**RE: Pinnacle Bellevue North**  
**Project #: 21-103195-LD; 21-103192-LP**  
**Revision Request #3**

The Development Review Committee (DRC) has reviewed the plans submitted July 21, 2022. Below are additional comments and revision requests from the City's review team. **Please note that additional information may be requested as a result of our review of your resubmittal.**

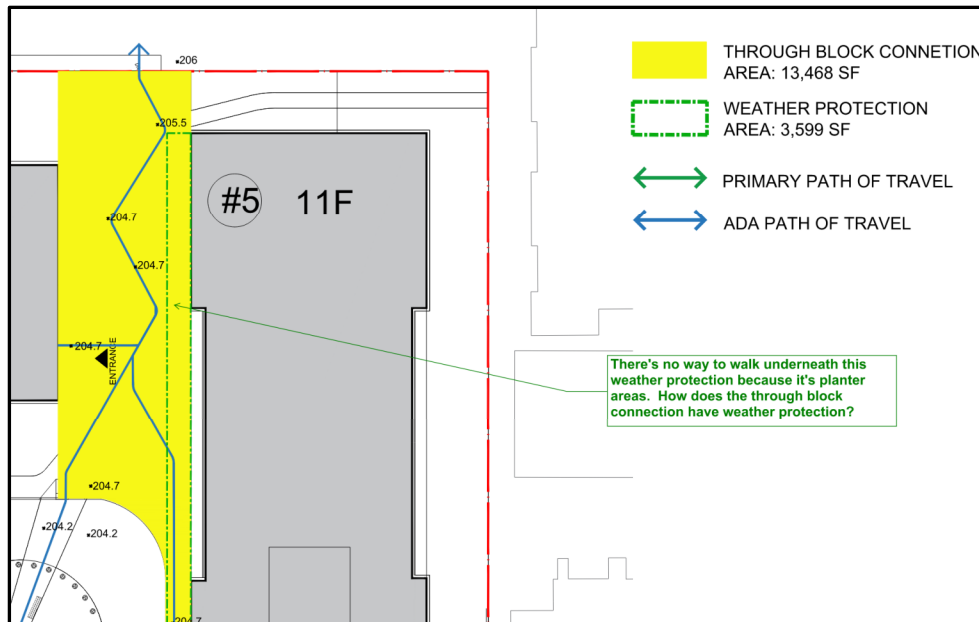
1. The plaza design adjacent to NE 10<sup>th</sup> street is still lacking the superior design and activation needed to be considered as an outdoor plaza for a project of this size. The current design is similar to the previous design and is not moving in the direction needed to gain approval. We are specifically looking for a plaza that engages better with the proposed development (building façade, interior active use/retail spaces - particularly the grocery store, etc.) and with the public using the adjacent sidewalk.

At this point, we strongly suggest scheduling a working design meeting/charette with your design team and Land Use to review these comments and discuss your design options to get toward an approvable design that works for both your team and the City. We recommend having this meeting in person, if possible, since it's always easier to discuss design ideas around the same table, rather than virtually. Note that some of the comments below are repetitive from the previous revision letter. You will need to review the design guidelines for open space here <https://bellevue.municipal.codes/LUC/20.25A.160.E> and provide a design that corresponds to each design criteria.

- How is the plaza activated if there is no real interface or physical connection into and out of the adjacent active use(s)? In other words, how is this plaza to be utilized? What makes this plaza design engaging and accessible by all? There does not appear to be anything in the plaza design to draw anyone into it. Strive for a variety of spaces and experiences and an overall design that is memorable.

- Provide a sense of place and diversity of activities in the plaza design. There is also an opportunity to provide a dual purpose or extension of the store behind it.

- How will art be integrated into this plaza design? Provide concepts. Final design and approval of art can be conditioned for TCO.
- There isn't any weather protected area in this plaza design. How is the plaza to be utilized year-round by residents and visitors? Weather protection attached to the building doesn't provide weather protection to users, except at entry points.

- Consider including the covered area in front of the grocery into the overall plaza design so that there is more of an all-season experience and an inviting space(s) for patrons of the grocery to eat, enjoy coffee, linger, people watch, etc.

- The area outside of the entry vestibule for the grocery now is just one large, paved walkway to the store. To meet the criteria and requirements for a public open space, this area needs to be designed to be more than just an outdoor

paved area., As mentioned above, this area should be treated as more of an extension of the plaza space to the west and be activated (both physically and visually) by the adjacent retail spaces.

- Consider breaking up the plaza into two different sections that have connection to the adjacent sidewalk grade to meet the 30" requirement. The space closer to the entry plaza could be more activated by the adjacent retail space.
